CITY OF NOVI CITY COUNCIL
MARCH 14, 2022

SUBJECT: Approval of the request of Singh Development LLC for JSP 20-27 Griffin Novi for approval of Preliminary Site Plan with a PD-2 option, a Special Land Use permit, Wetland Permit and Storm Water Management plan. The subject property is located at the southeast corner of Twelve Mile Road and Twelve Oaks Mall access drive in Section 14. The applicant proposes to utilize the Planned Development 2 (PD-2) option to develop 174 multi-family residential units on a vacant 7.5 acre parcel.

PLANNING REVIEW

2nd Revised Preliminary Site Plan

Figure 1

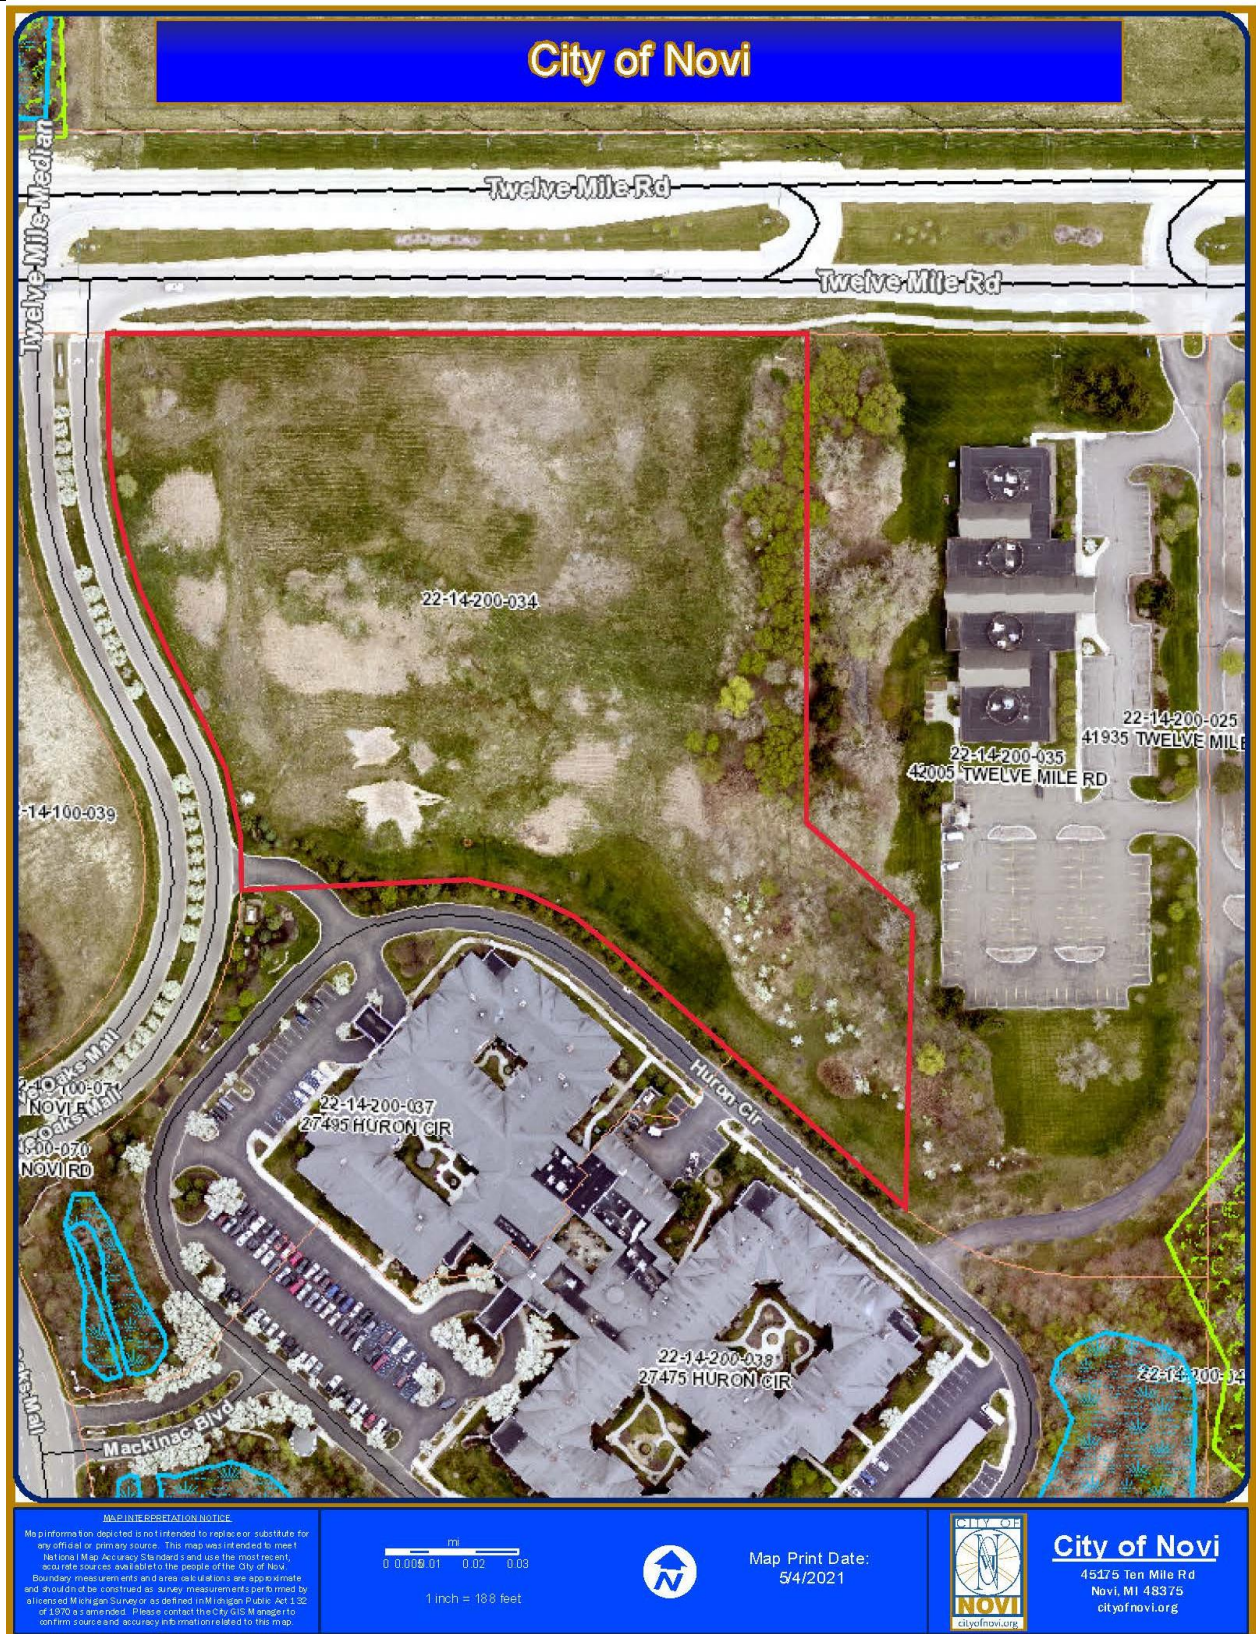
MSG reviewed The City of Novi Wetlands Maps and the Michigan Department of Environment, Great Lakes, and Energy (EGLE) Wetlands Map Viewer for the project site (Figures 1 and 2, respectively). The project site contains wetlands as identified on National Wetland Inventory (NWI) and Michigan Resource Inventory System (MIRIS) maps (Figure 2). NWI and MIRIS wetlands are identified through interpretation of topographic data and aerial photographs by the associated governmental bodies.

Figure 3 | Approximate potential expansion of Wetland A.

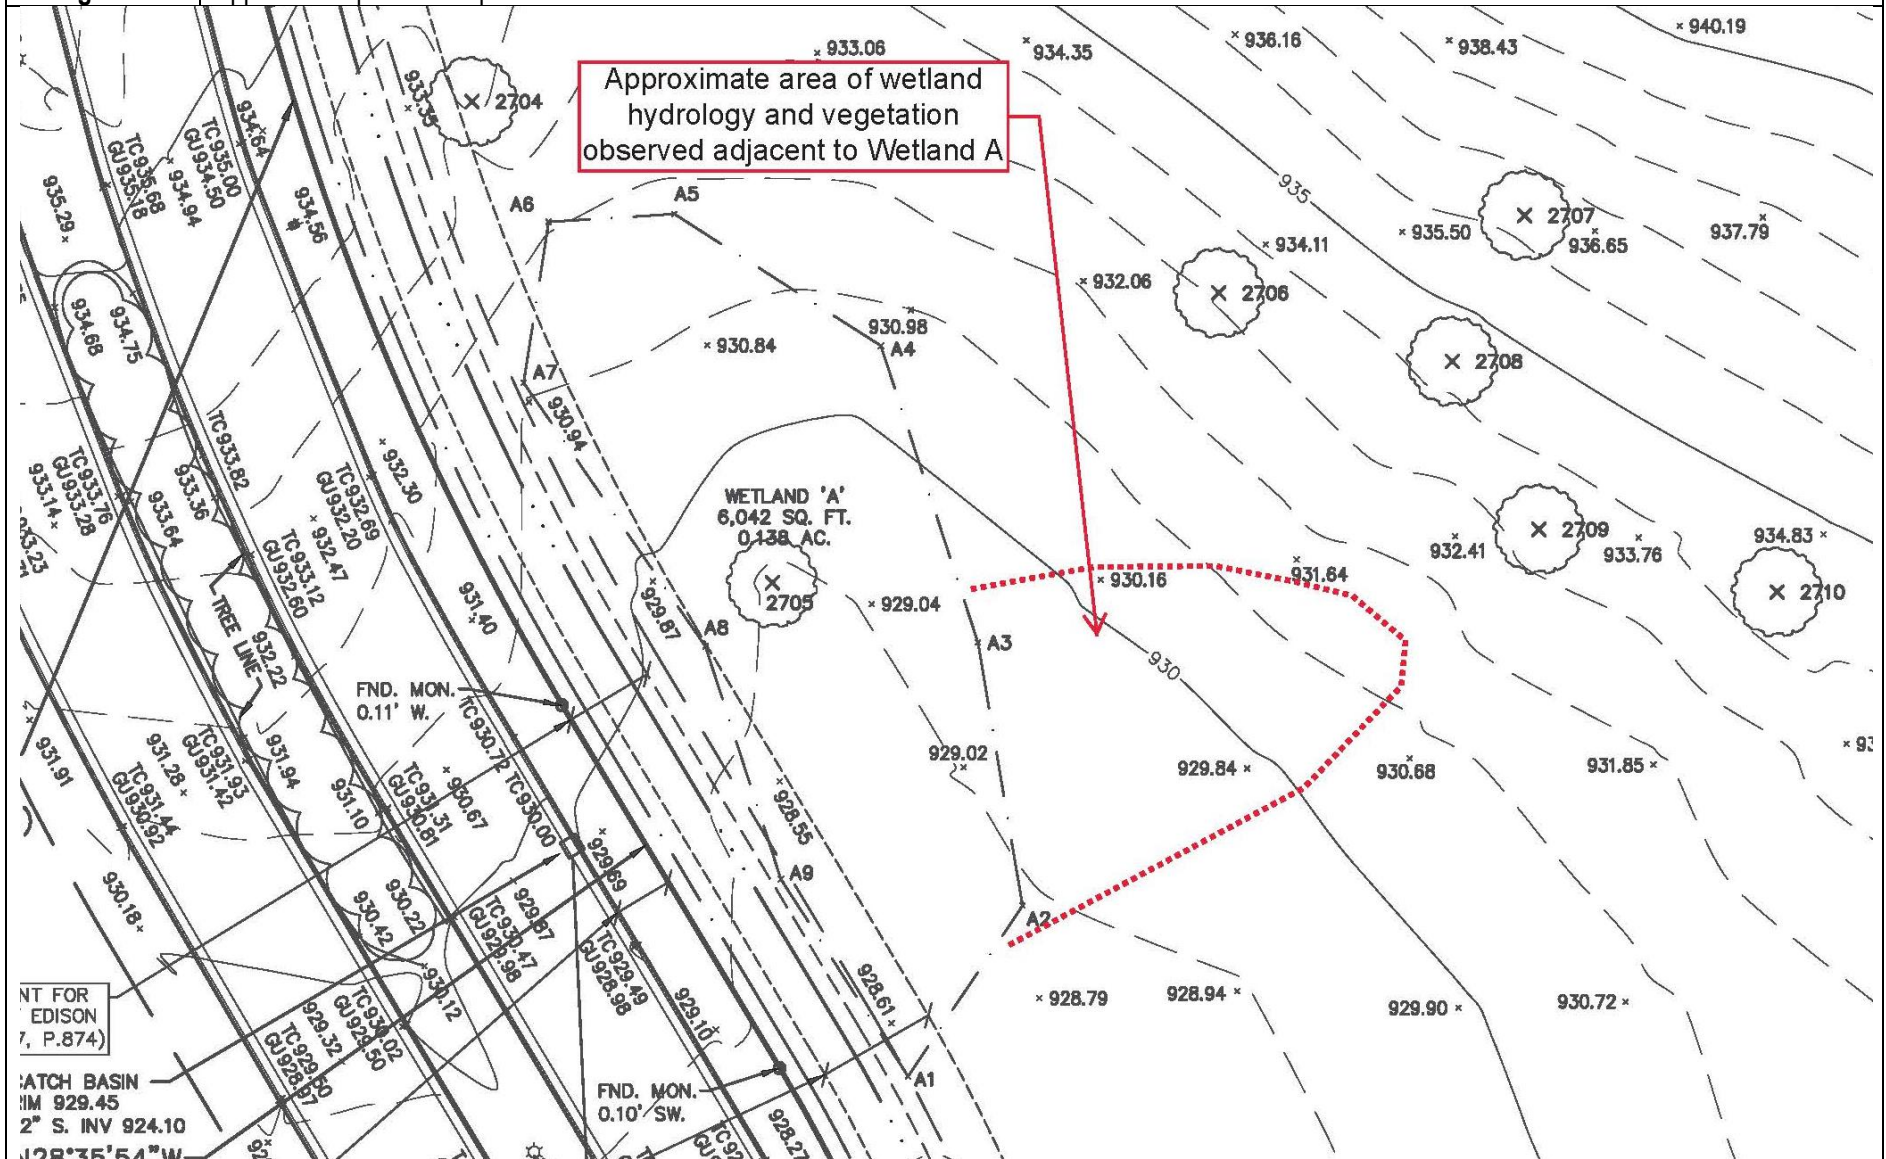
It is MSG's opinion additional information regarding the limits of Wetland A is necessary. MSG observed a swale to the east of the southern end of Wetland A that included evidence of wetland hydrology and wetland vegetation at the (Photo 3, Photo 4, and Figure 3). It is unclear to MSG why this area was not included in the limits of Wetland A.

MSG reviewed the Response to Comments for Uptown Place Development letter prepared by Wilson Road Group (WRG) dated July 31, 2021. MSG notes WRG expanded the limits of Wetland A as suggested by MSG. The revised size of Wetland A was identified by WRG to be 0.206 acre, bringing the combined acreage for Wetlands A and B to 0.241 acres, which is below the City's 0.25-acre threshold for compensatory mitigation. The revised wetland acreage is depicted on Sheet PSP8 of the rPSP. MSG observed the square footage of Wetland A noted on Sheet PSP8 was not similarly adjusted however, and suggests this typo be corrected.
